San Francisco Bay Conservation and Development Commission

Application Summary

Number: BCDC Permit Application No. 2016.006.00
Date Filed: July 17, 2017
90th Day: October 15, 2017
Staff Assigned: Erik Buehmann (415/352-3645; erik.buehmann@bcdc.ca.gov)

Applicant: Port of San Francisco (“Port”)

Vicinity Map

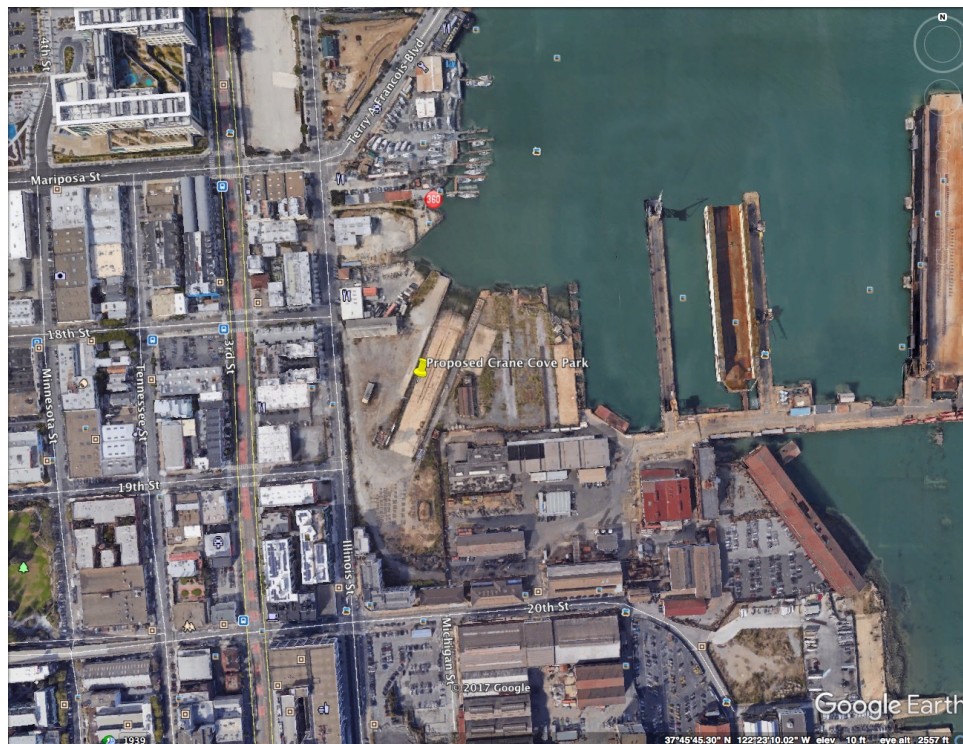
Location: Within the northwest area of the Port of San Francisco’s Pier 70 area, east of Illinois Street, between Mariposa and 19th Streets, in the City and County of San Francisco (Exhibit 1).
